RECOMMENDATION

2100 E. DENNY WAY
SEATTLE, WA 98112

3036655-LU **TAXUS HOUSE APARTMENTS**
ADMINISTRATIVE DESIGN REVIEW

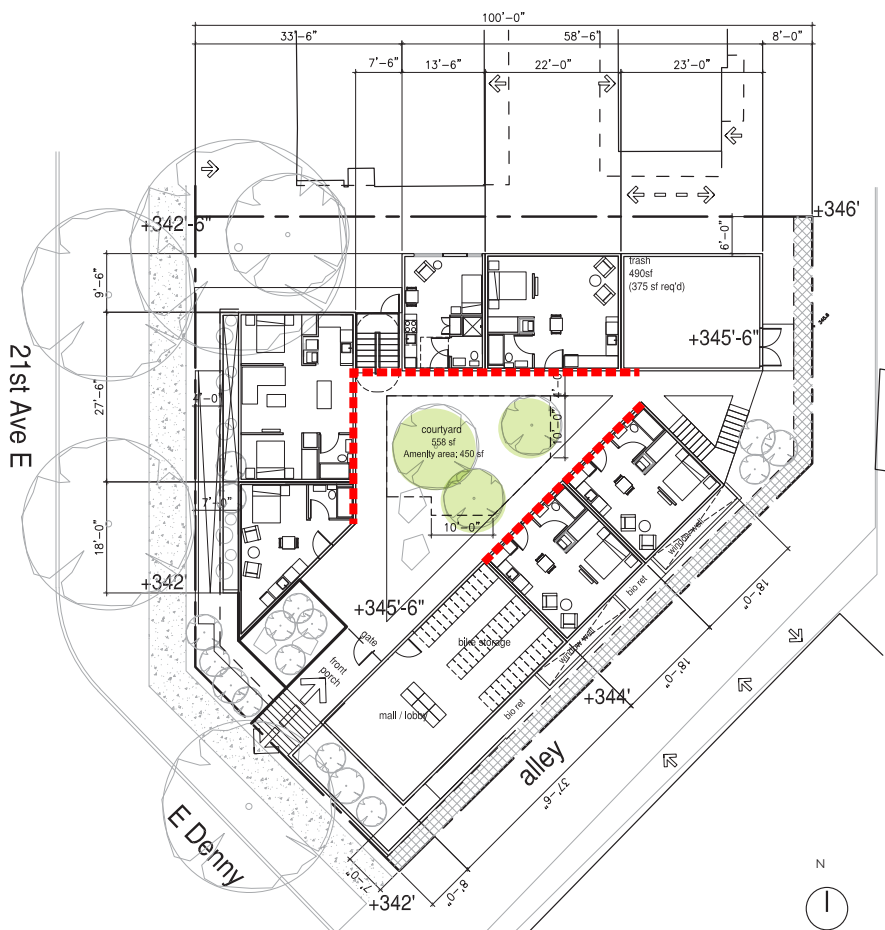
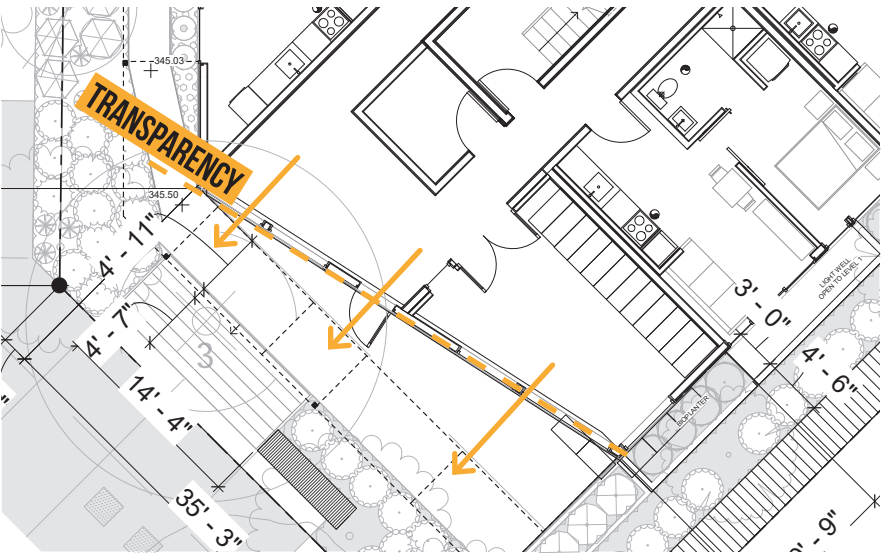
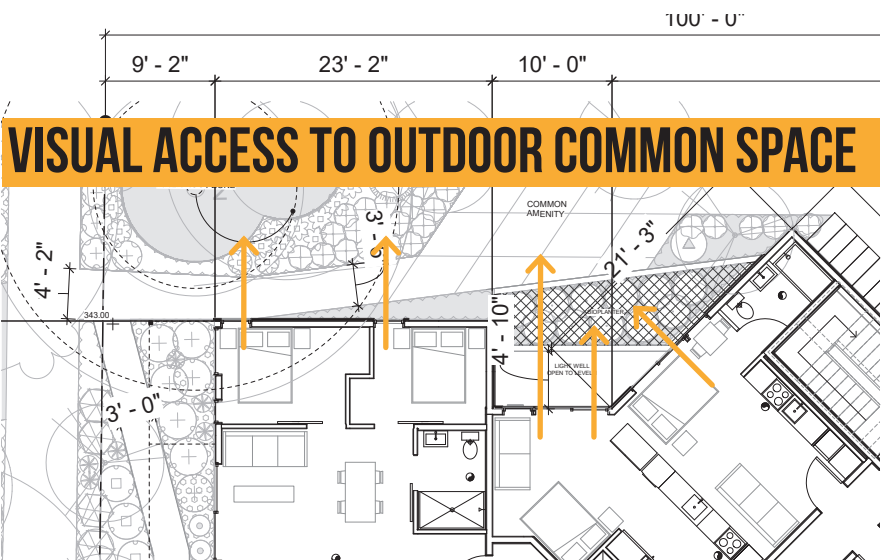
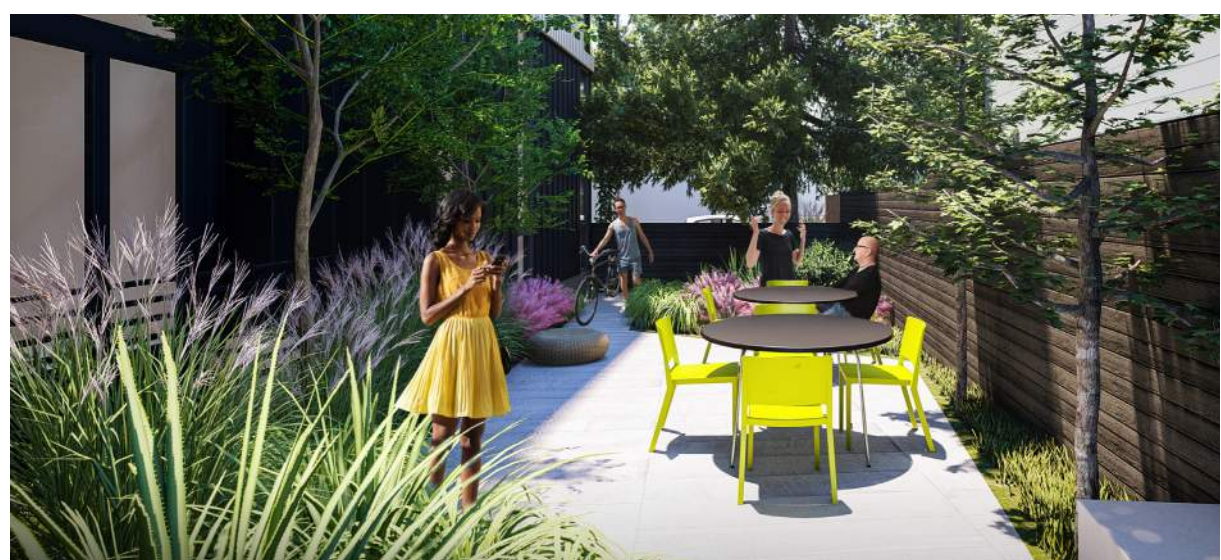
d. Staff directs further study of the relationship between interior and exterior common spaces, and specifically prioritizes Design Guideline DC3-A-1, Interior/Exterior. Consider how the lobby relates to the “front porch,” central courtyard, and public realm. (DC3-A-1)

d. The developed design further considers the existing the relationship between the interior common spaces and the exterior entry to the project development. The lobby room has been expanded and a seating area is now proposed directly facing the front porch. This area is visually connected to the pedestrian realm of the adjacent sidewalk and acts as a semi-public arena for interaction, gathering and entry into the building. Seating areas, adjacent to the main entry stairs have also been provided to further provide amenity to the public realm of the project.

The lobby and the covered common spaces are bleached out into the front stoop through the use of transparent materials .

Along the North, the units have visual connections to the main outdoor common spaces (floor 1-5). To further allow more engagement, Juliette balconies are proposed.

EDG - NE Aerial View

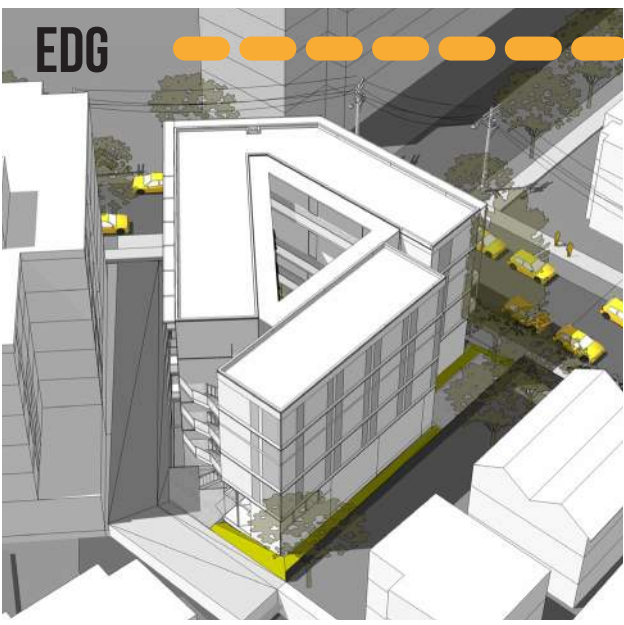
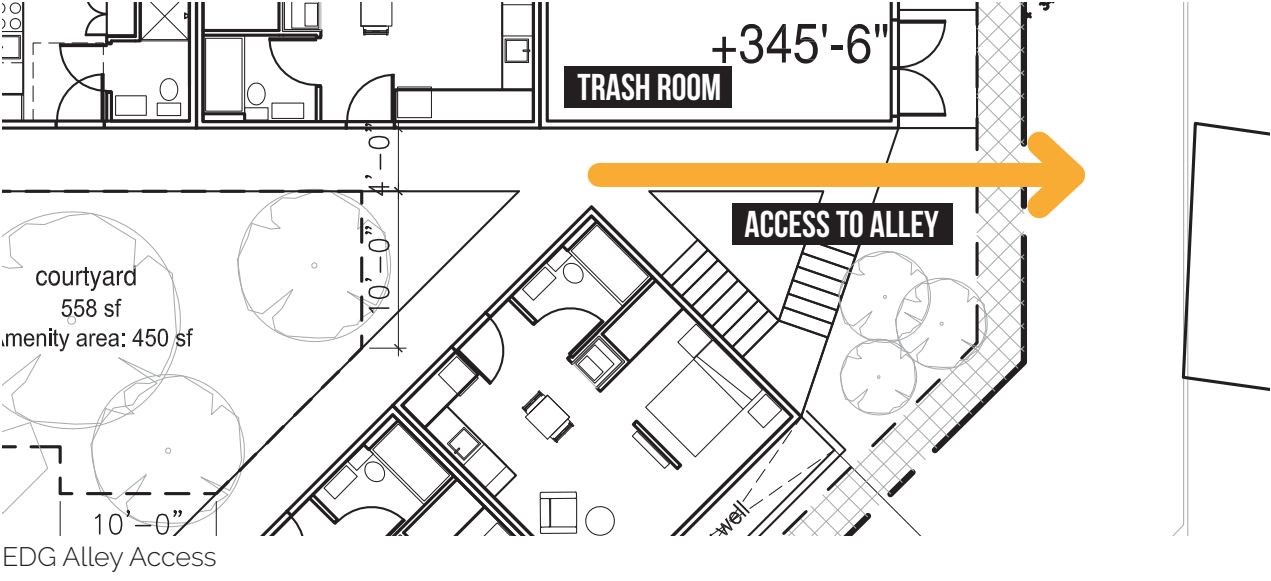
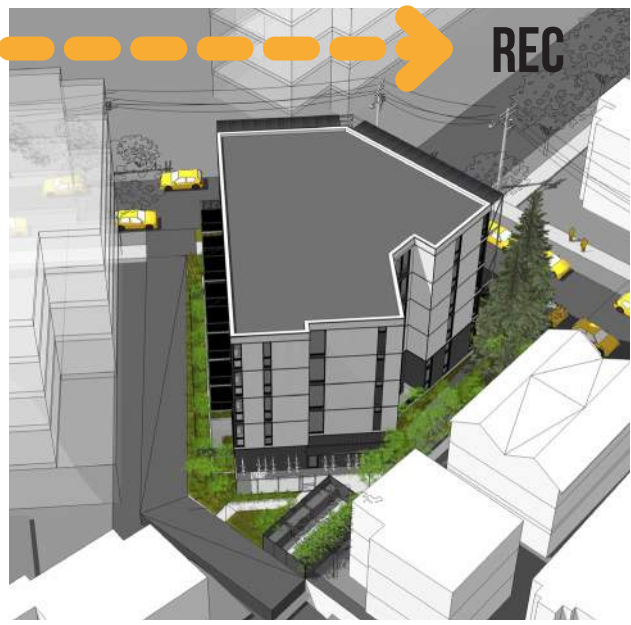
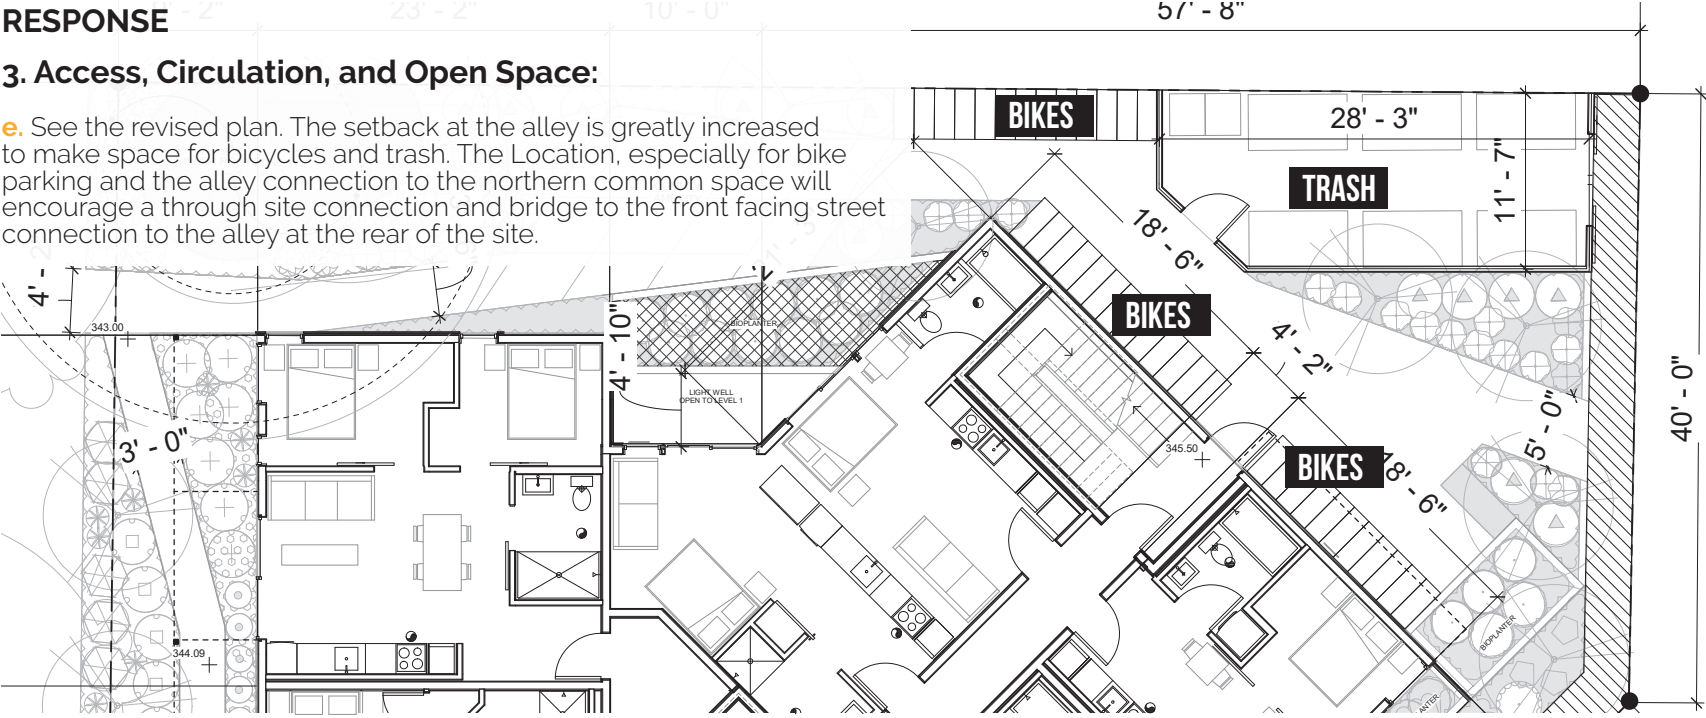
The **Board directs further development of the alley access.** The board suggested on providing **adequate lighting and a well-designed entry,** and reduce the visual impacts of the service uses.

e. Staff notes the location and design of the eastern stairwell may encourage pedestrian use of the alley and specifically prioritizes Central Area Design Guideline PL1-3-c, Preserve Alleys for Access and Use. To ensure active usage, provide adequate lighting and a well-designed entry, and reduce the visual impacts of service uses. Provide more information on the adjacent uses, across the alley, in the Recommendation packet. (PL1-3-c, DC1-C-4)

e. See the revised plan. The setback at the alley is greatly increased to make space for bicycles and trash. The Location, especially for bike parking and the alley connection to the northern common space will encourage a through site connection and bridge to the front facing street connection to the alley at the rear of the site.

Light-well locations

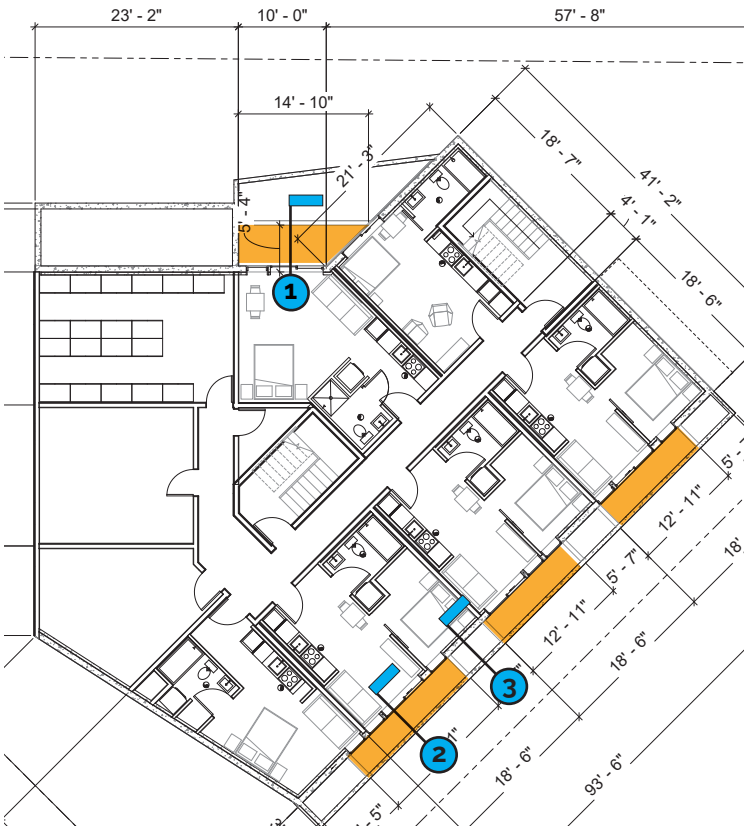
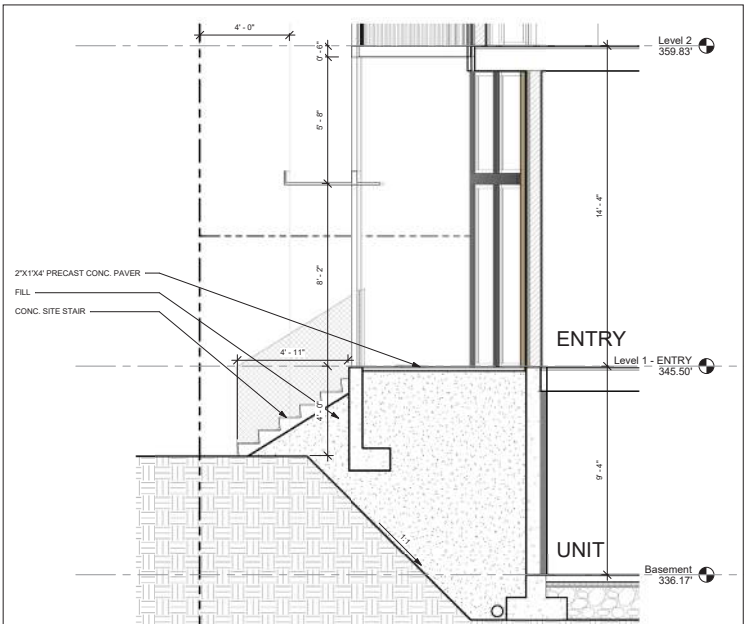
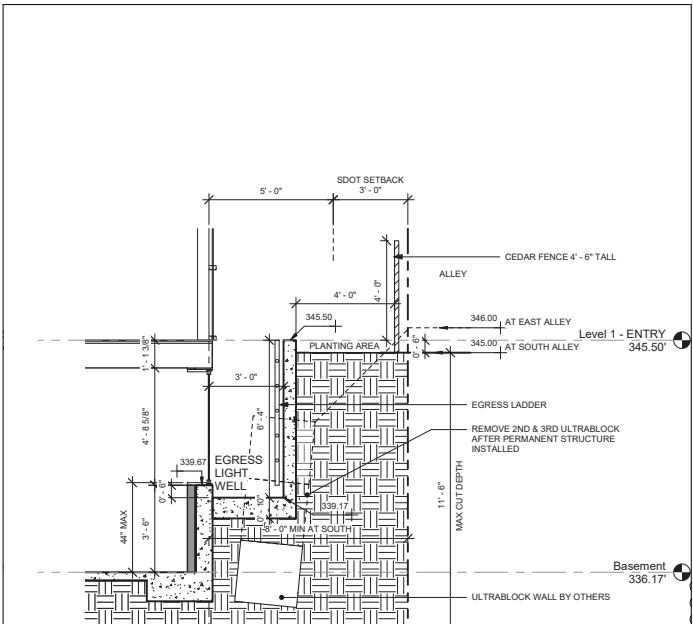
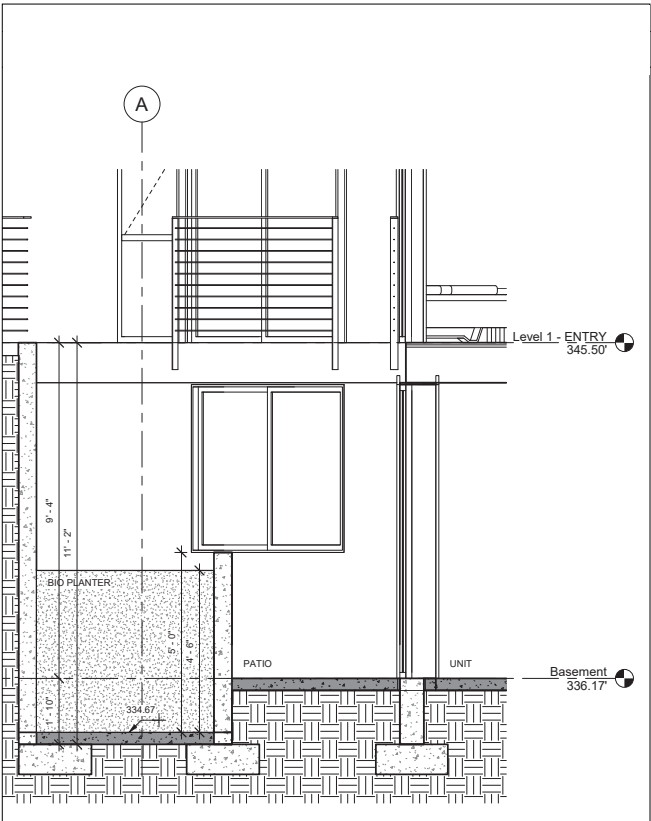
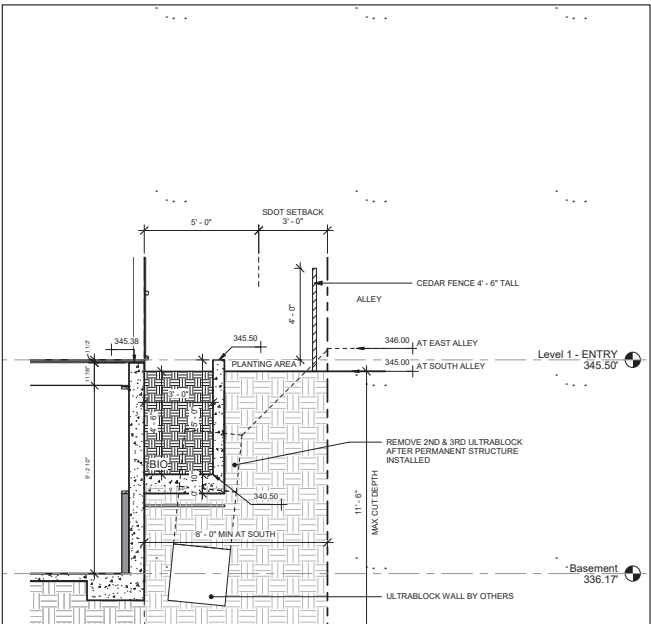
The Board suggested further study of relocating the window well on the northwest corner to provide more privacy. The board further suggested a design solution to provide a buffer between the alley and the units.

e. Staff is concerned about the impact of alley traffic/use on residents of basement level units. Explore design solutions, such as landscape buffers or material screening, that promote privacy for the residents of the basement level units and buffer alley activity. (PL3-B-1, PL3-B-2, DC1)
